# **Rebuttal Expert Report of Konrad J. Banaszak**

**IN THE UNITED STATES DISTRICT COURT  
FOR THE NORTHERN DISTRICT OF ILLINOIS,  
WESTERN DIVISION**

Case No. 13-cv-50348

**REBUTTAL EXPERT REPORT**

**Analysis of Dr. Vagt's Exhibits I and K**

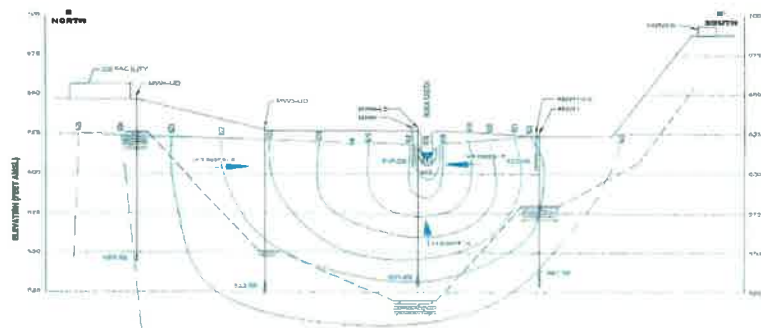
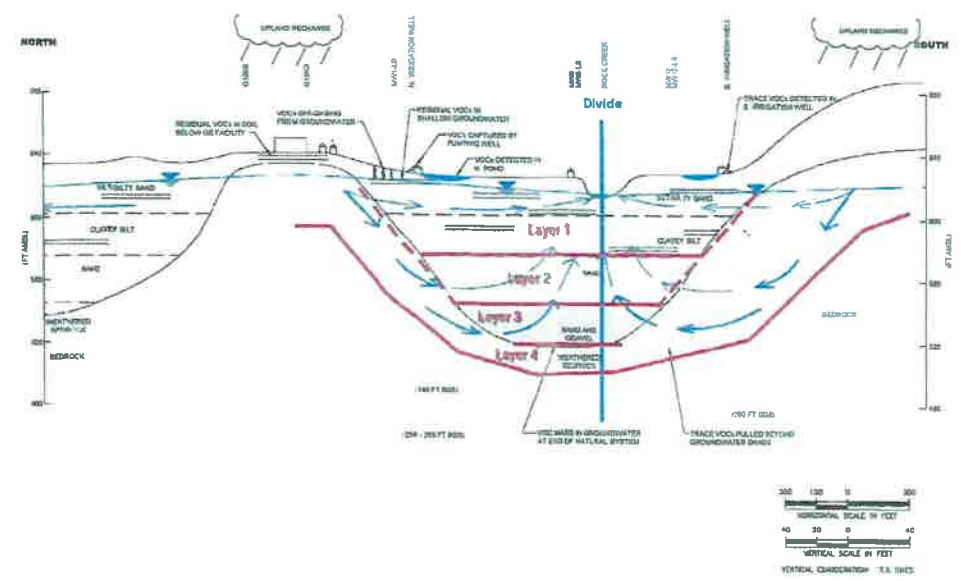
2. Dr. Vagt's Exhibit I disagrees with known information. The cross section does not show the existence of the pond south of Rock Creek that is certainly there and is shown in Exhibit F. Exhibit K also disagrees with known information. The south supply well is in the wrong location, and accordingly at the wrong elevation.

3. Putting Dr. Vagt's Exhibits I and K together, the attached Figure 1, shows that Dr. Vagt has presented two different ideas with respect to groundwater flow. Exhibit I corresponds to all the mathematical analyses by Dr. Vagt, but the direction of the hydraulic gradient conflicts with the major direction of groundwater flow shown on Exhibit K. Dr. Vagt states that on his Section B-B', "Arrows have been added to show the directions of the gradients that drive groundwater flow on the north and south sides of Rock Creek and groundwater flow below the creek," (See p. 4-4, Section 4.1.2 of Dr. Vagt's Expert Report) and "it is the gradients, not the stratigraphy that drive groundwater migration (See p. 5-5 of Dr. Vagt's Expert Report, second paragraph under Part B)." Yet Dr. Vagt's own Exhibit K clearly shows stratigraphy is more important, as the main flow is down the upper bedrock zone. Flow like that shown on Exhibit K, not like that shown in Exhibit I, would allow contamination to reach the deep gravel and the broken up bedrock which is tapped by monitoring wells MW7-LS and MW8-LS, both adjacent to Rock Creek.

According to the flow postulated in Dr. Vagt's opinion based upon Exhibit I, all of the water flowing into layers 3 and 4 and the water flowing in the clay portion of layer 1 of Exhibit K must come from Dr. Vagt's layer 4 under the GE facility to the point where the top of the clay portion of layer 1 intersects the top of layer 4. These observations make the calculations (presented later in Dr. Vagt's opinion) of amounts groundwater moving in various zones to Rock Creek dubious at best.
